Well Name: SHANGHAI ROOSTER 15-3 FEDERAL	Well Location: T25S / R29E / SEC 15 / SESE / 32.123701 / -103.967482	County or Parish/State: EDDY / NM
Well Number: 107H	Type of Well: OIL WELL	Allottee or Tribe Name:
Lease Number: NMNM14778	Unit or CA Name:	Unit or CA Number:
US Well Number: 3001550097	Well Status: Approved Application for Permit to Drill	Operator: XTO ENERGY INCORPORATED

Notice of Intent

Type of Action: APD Change

Procedure Description: **Well Name Change, Well Number Change, Surface Hole Location Change, Bottom Hole Location Change, and First and Last Take Point Changes XTO Energy, Inc. requests permission to make the following changes to the originalAPD: Change Well Name/Number from Shanghai Rooster 22-27 Fed 907H to Shanghai Rooster 15-3 Fed 107H Change SHL fr/340'FSL & 1160'FEL to 341' FSL & 1185' FEL, Section 15-T25S-R29E No Additional Surface Disturbance Change BHL fr/200'FSL& 990'FEL, Section 27-T25S-R29E to 50'FNL & 1320'FEL, Section 3-T25S-R29E Change FTP fr/330'FNL & 990'FEL to 100'FSL & 1320'FEL Change LTP fr/330'FSL & 990'FEL to 100'FNL & 1320'FEL Attachments: C102 Drilling Program Directional Plan

Wellhead diagram during offline cementing operations

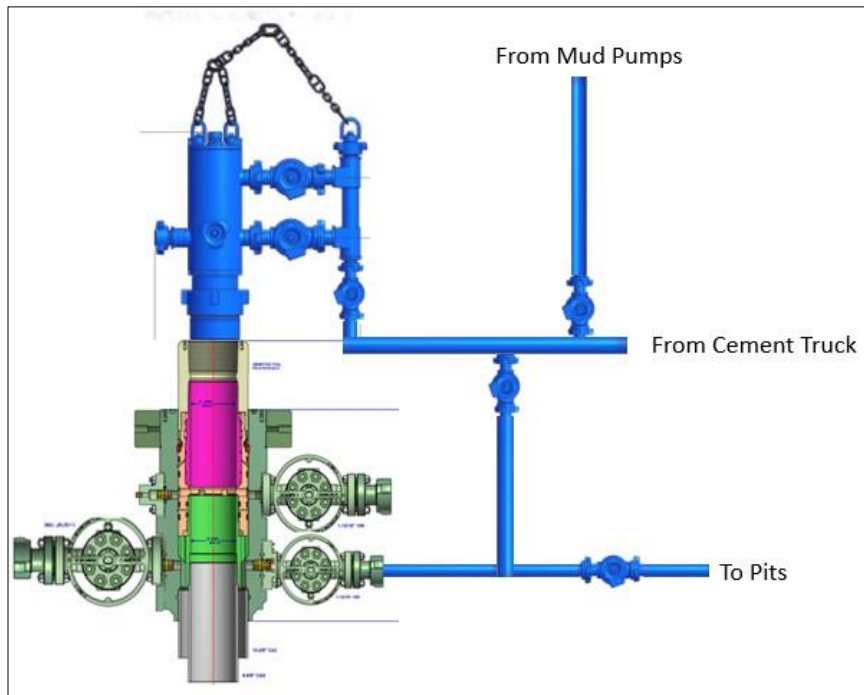
10. Circulate bottoms up with cement truck
 - a. If gas is present on bottoms up, well will be shut in and returns rerouted through gas buster to handle entrained gas
 - b. Max anticipated time before circulating with cement truck is 6 hrs
11. Perform cement job taking returns from the annulus wellhead valve
12. Confirm well is static and floats are holding after cement job
13. Remove cement equipment, offline cement tools and install night cap with pressure gauge for monitoring.

Figure 1: Winch System attached to BOP Stack

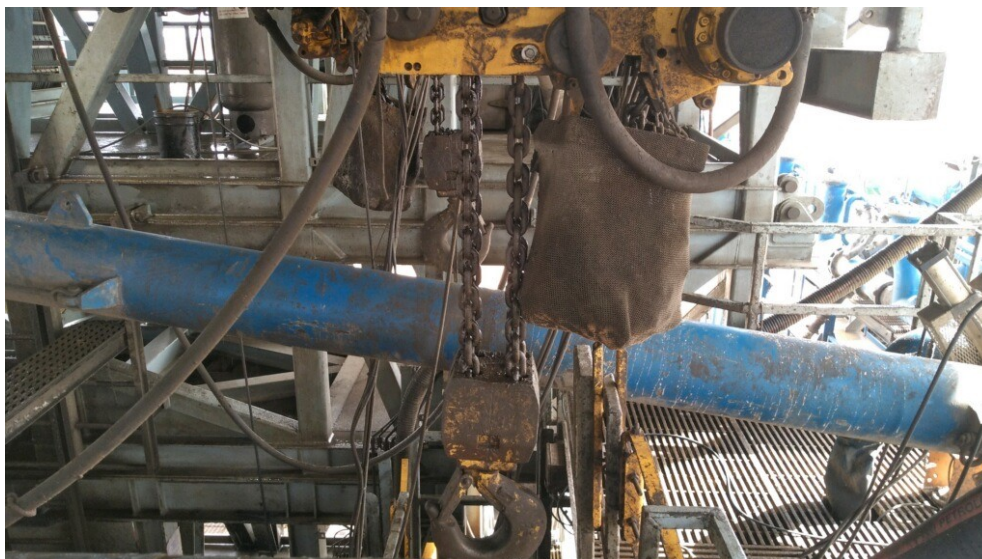
XTO Energy requests a variance to ONLY test broken pressure seals on the BOPE and function test BOP when skidding a drilling rig between multiple wells on a pad.

Note: Picture below highlights BOP components that will be tested during batch operations

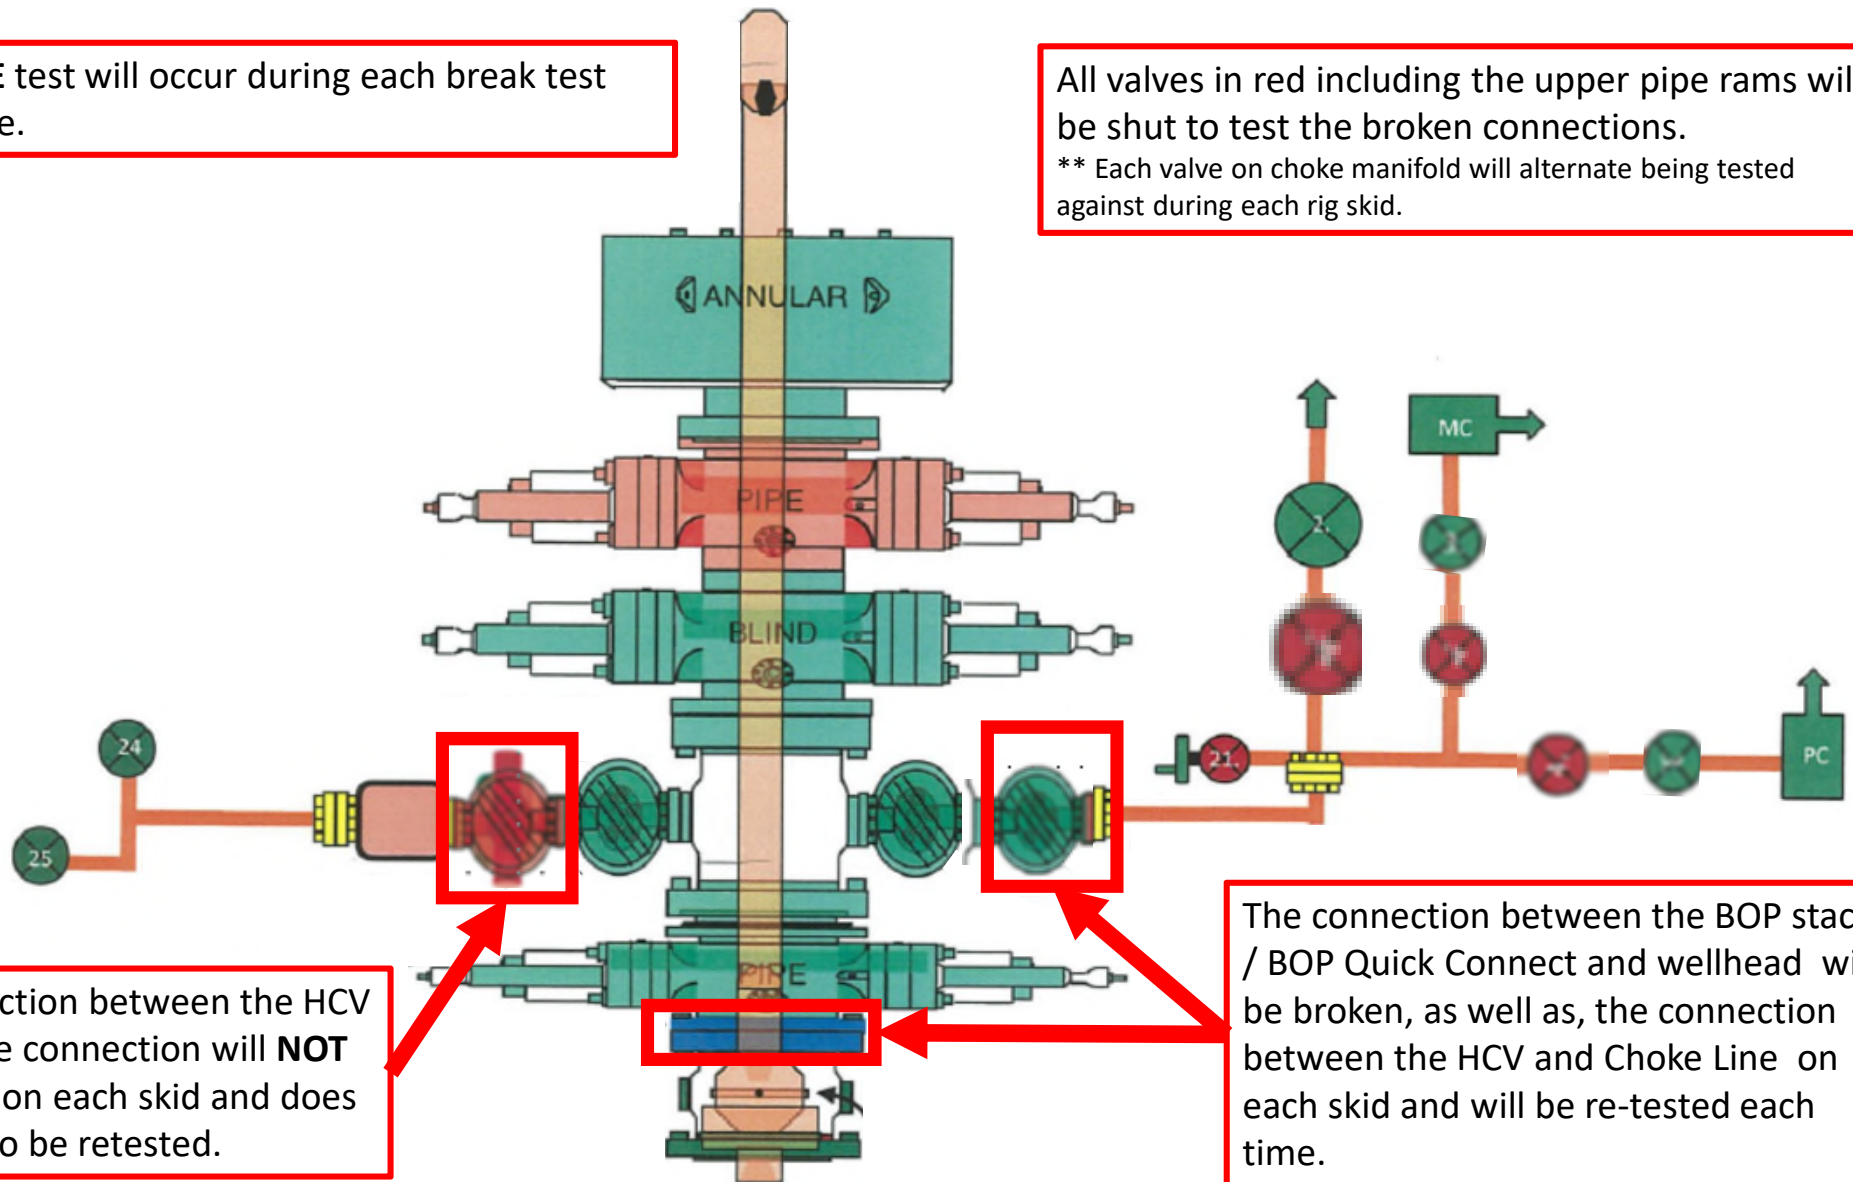
All valves in red including the upper pipe rams will be shut to test the broken connections.

The connection between the HCV and kill line connection will **NOT** be broken on each skid and does not need to be retested.

The connection between the BOP stack / BOP Quick Connect and wellhead will be broken, as well as, the connection between the HCV and Choke Line on each skid and will be re-tested each time.
